Subject: Response to City Review Comments  
Proposed Hotel Expansion  
The Ritz-Carlton Laguna Niguel  
1 Ritz Carlton Drive  
Dana Point, California

In accordance with your request, Ninyo & Moore has reviewed the comments prepared by Zeiser Kling Consultants, Inc., on behalf of the City of Dana Point regarding our referenced geotechnical evaluation report dated August 9, 2007, for the Ritz-Carlton Hotel Expansion project. Our responses to the City comments requesting response/further evaluation are presented below. A copy of the City of Dana Point Geotechnical Report Review checklist is included in Attachment A for reference.

<b>Ninyo &amp; Moore</b>		<b>CROSS SECTION B-B'</b>	FIGURE
PROJECT NO.	DATE	PROPOSED RITZ-CARLTON HOTEL EXPANSION 1 RITZ CARLTON DRIVE DANA POINT, CALIFORNIA	<b>3</b>
207118001	3/08

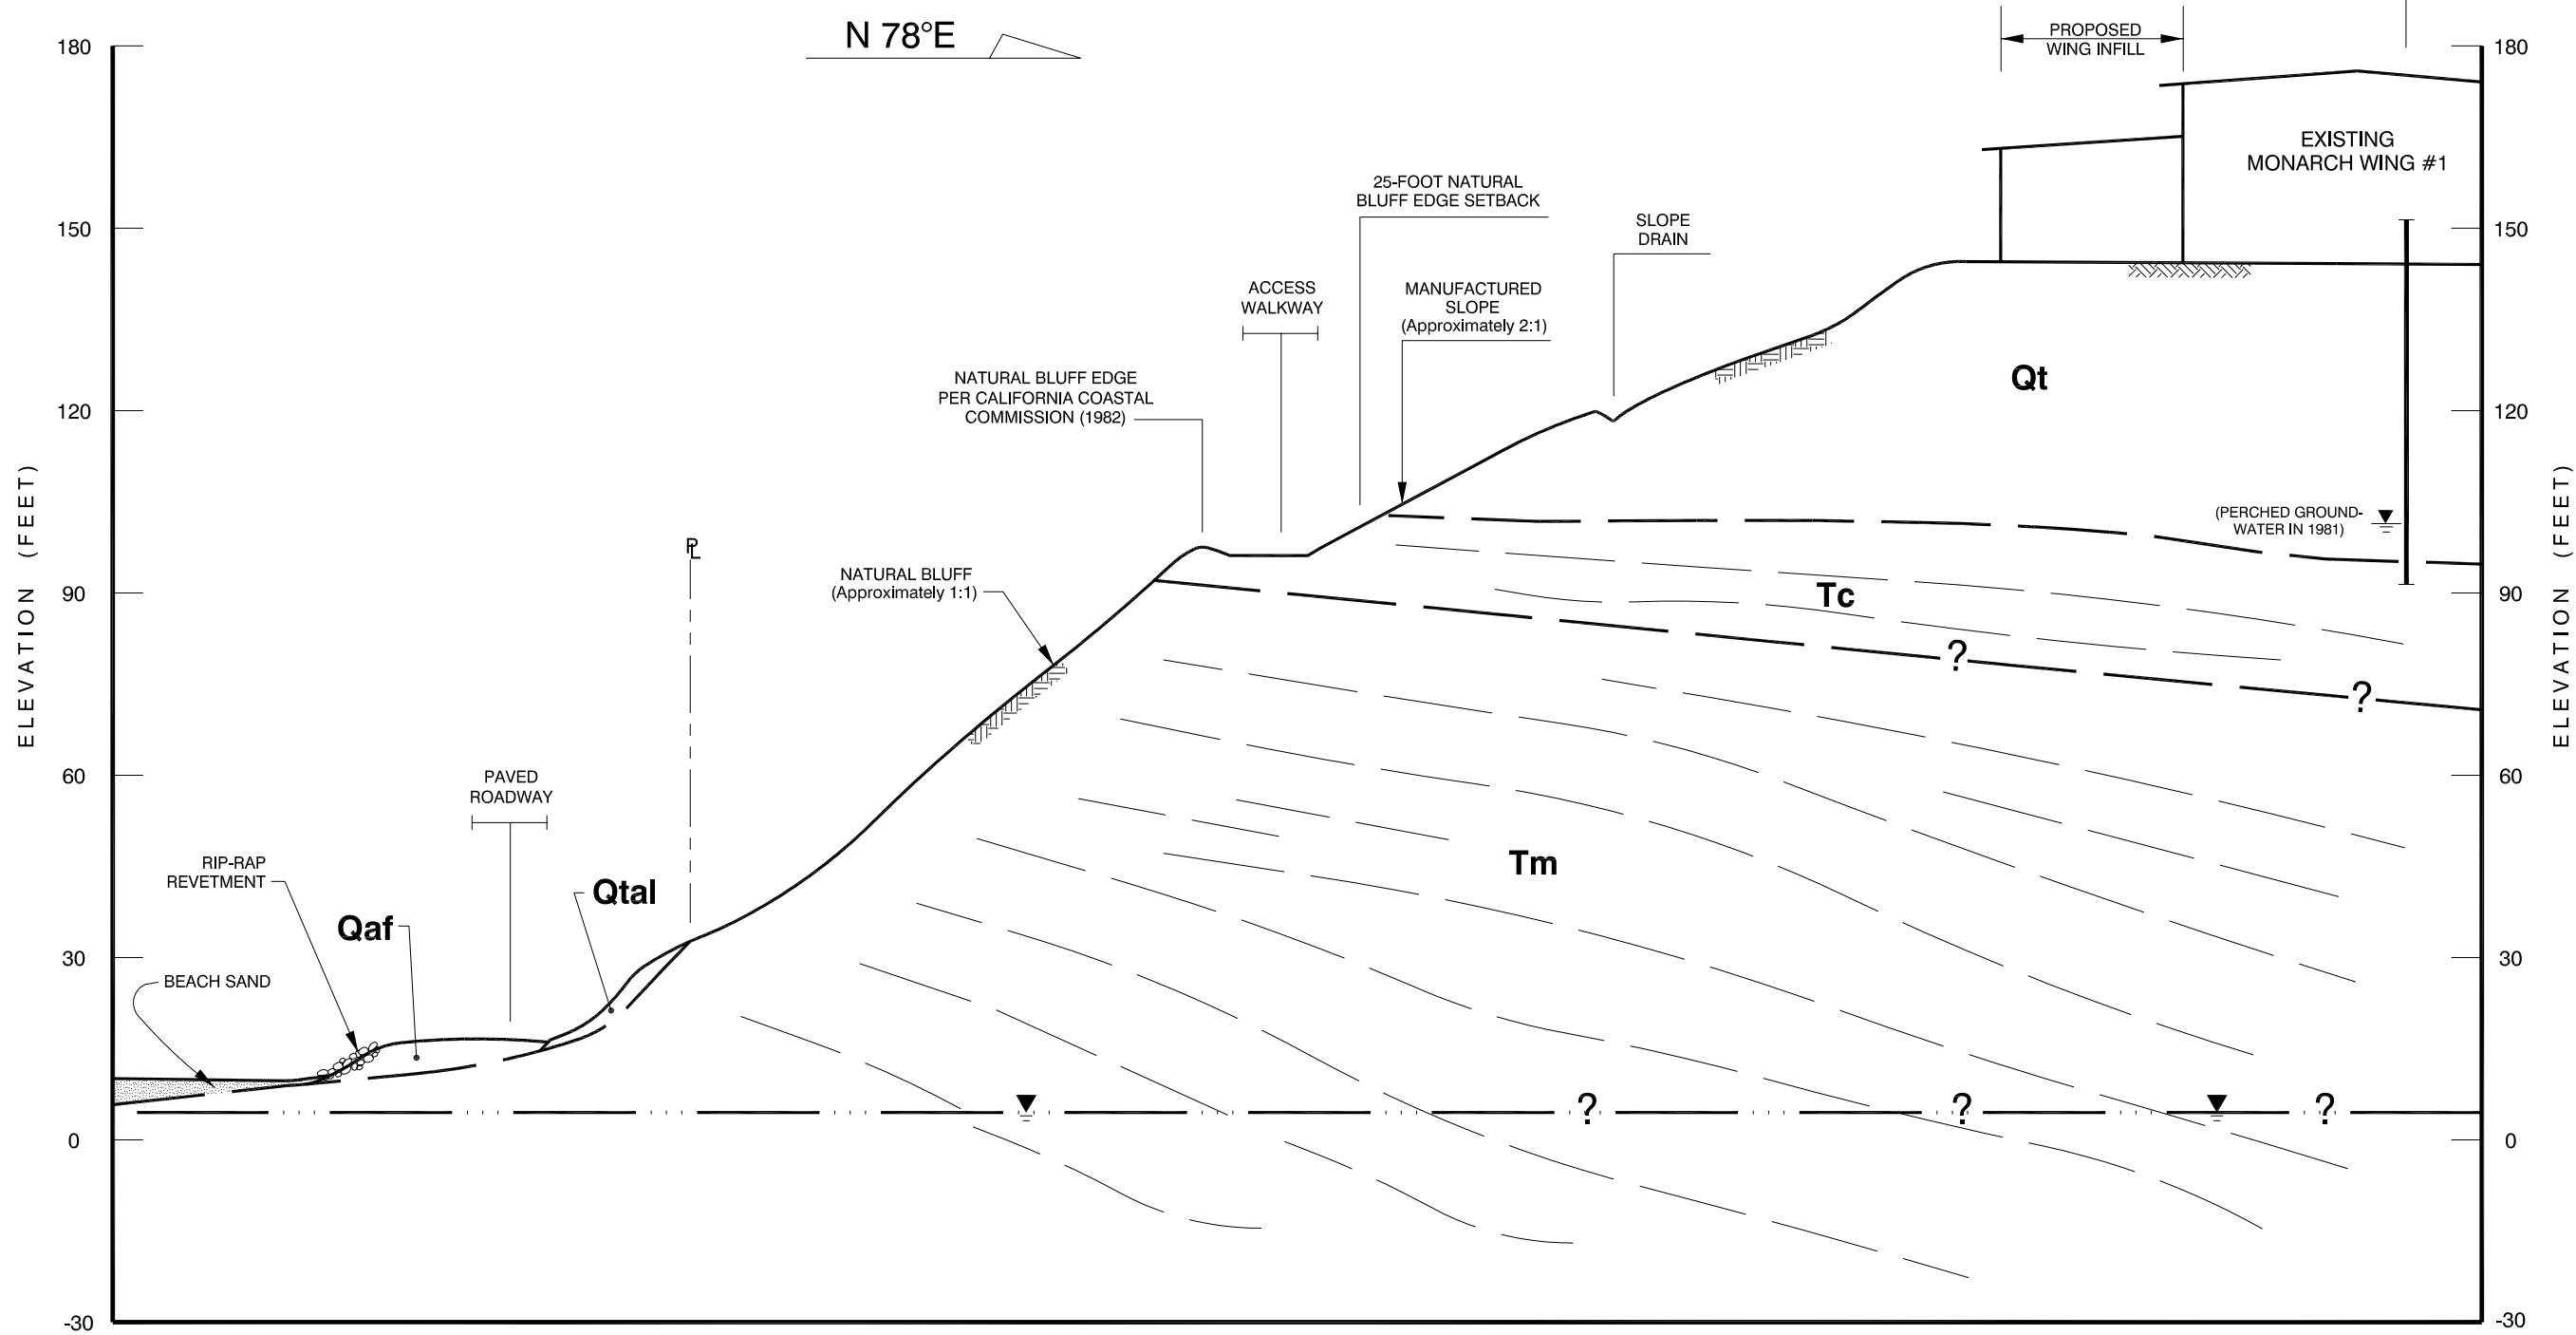
7. Please provide geologic cross-sections and slope stability analyses through portions of the proposed additions. Prior geotechnical data may be utilized at this stage to evaluate slope stability and geologic conditions. This information will be used to evaluate a variance to the coastal bluff setback. Logs of all relevant exploration points should be included.

Geologic Cross Sections A-A', B-B', and C-C' were prepared in order to perform preliminary slope stability analysis in the vicinity of the proposed bungalows and infill construction on the south, west, and north sides of the hotel (Figures 2, 3, and 4). Slope stability analysis was performed using the GSTABL7 computer program and the Modified Bishop Method. Our analysis included evaluation of the global stability (top to bottom of bluff) and separate evaluations of the stability of the upper terrace deposits for Sections A and B. An evaluation of both static and pseudostatic stability was performed. The shear strength parameters used in the slope stability
